Addendum 71: Regulation No. 72

Amendment 1

Supplement 1 to this Regulation in its original form – Date of entry into force: 27 October 1992

**UNIFORM PROVISIONS CONCERNING THE APPROVAL OF MOTOR CYCLE
HEADLAMPS EMITTING AN ASYMMETRICAL PASSING BEAM AND A
DRIVING BEAM AND EQUIPPED WITH HALOGEN LAMPS (HS₁ LAMPS)**

Annex 6 - Appendix 2

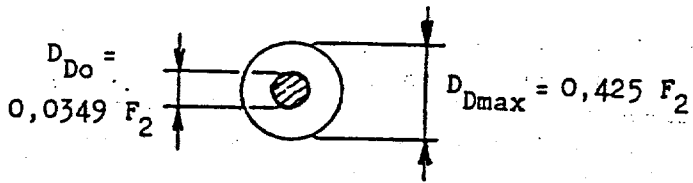
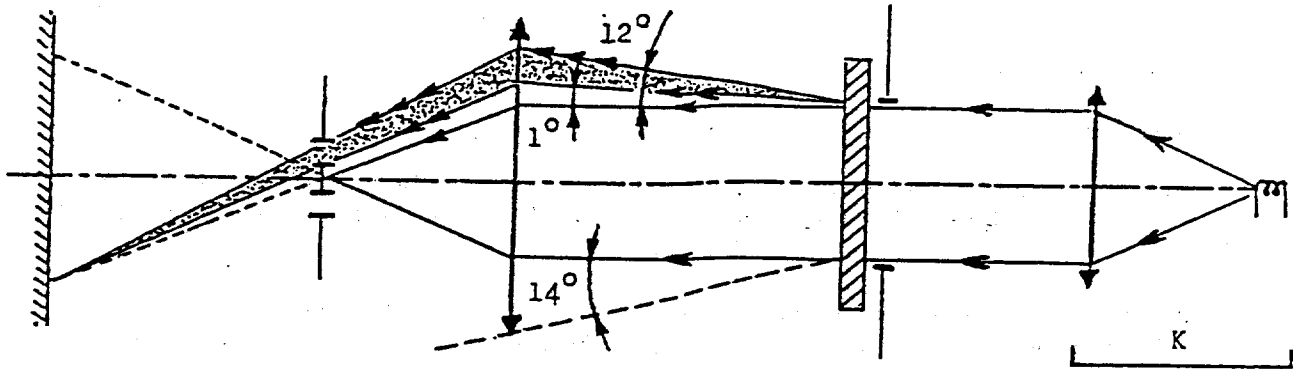
METHOD OF MEASUREMENT OF THE DIFFUSION AND TRANSMISSION OF LIGHT

1. EQUIPMENT (see figure)

The beam of a collimator K with a half divergence $\frac{\beta}{2} = 17.4 \times 10^4$ rd is limited by a diaphragm D_T with an opening of 6 mm against which the sample stand is placed.

A convergent achromatic lens L_2 , corrected for spherical aberrations, links the diaphragm D_T with the receiver R; the diameter of the lens L_2 shall be such that it does not diaphragm the light diffused by the sample in a cone with a half top angle of $\beta/2 = 14^\circ$.

An annular diaphragm D_D with angles $\frac{\alpha_0}{2} = 1^\circ$ and $\frac{\alpha_{max}}{2} = 12^\circ$ is placed in an image focal plane of the lens L_2 .

The non-transparent central part of the diaphragm is necessary in order to eliminate the light arriving directly from the light source. It shall be possible to remove the central part of the diaphragm from the light beam in such a manner that it returns exactly to its original position.

The distance $L_2 D_T$ and the focal length F_2 1/ of the lens L_2 shall be so chosen that the image of D_T completely covers the receiver R.
